Access Compliance Report

Public Rights-of-Way

Intersection ID: 30340	Main Street: DULIN_CREEK_BV	Cross Street: FOX_SWAMP_RD	Location: NW
ADA ID: D4CA6414A29B	Ramp Type: PerpDiag	Initial Pass/Fail: Fail	Overall Compliance: No
		Severity Score: 10

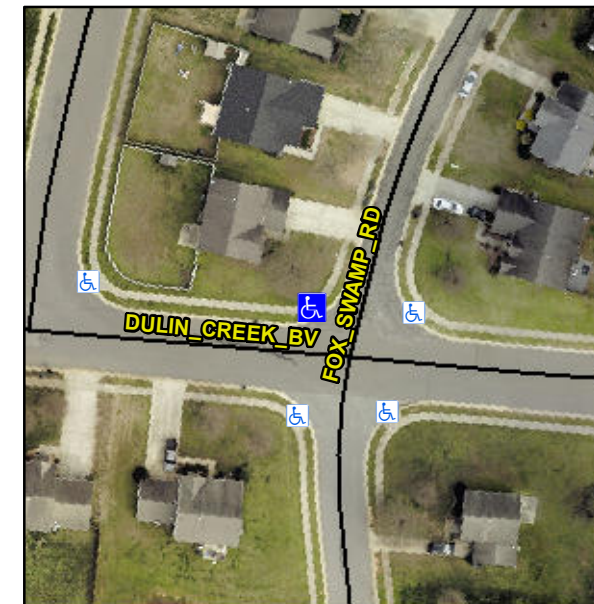
Not Found, R304.5.1, R304.5.3

Compliance	Description	Data	Compliance	Description	Data
N/A	Ramp Length (in)	42.0	Yes	Ramp Slope (%)	5.3
No	Ramp Width (in)	47.0	No	Ramp XSlope (%)	3.7
N/A	Flare Type LT	N/A	N/A	Flare Type RT	N/A
N/A	Flare Slope LT (%)	N/A	N/A	Flare Slope RT (%)	N/A
N/A	Flare Traversable LT?	N/A	N/A	Flare Traversable RT?	N/A
N/A	Landing Length (in)	N/A	N/A	DWS Provided?	N/A
N/A	Landing Width (in)	N/A	N/A	DWS Contrast?	N/A
N/A	Landing Slope (%)	N/A	N/A	DWS Length (in)	N/A
N/A	Landing X Slope (%)	N/A	N/A	DWS Full Width?	N/A
N/A	Landing Curb? (Y/N)	N/A	N/A	DWS Offset (in)	N/A
N/A	Shared Landing?	N/A			
N/A	Gutter Ponding?	N/A	N/A	Gutter Slope (%)	N/A
N/A	Gutter Lip Ht (in)	N/A	N/A	Gutter X Slope (%)	N/A
N/A	Painted X Walk1?	No	N/A	Painted X Walk2?	No
	X Walk 1 Direction	To S		X Walk 2 Direction	To E
N/A	X Walk 1 Width (in)	N/A	N/A	X Walk 2 Width (in)	N/A
	X Walk 1 Slope (%)	3.3		X Walk 2 Slope (%)	0.2
	X Walk 1 X Slope (%)	2.4		X Walk 2 X Slope (%)	1.3

Remove & Replace Curb Ramp With Two New Directional Ramps or Equivalent.
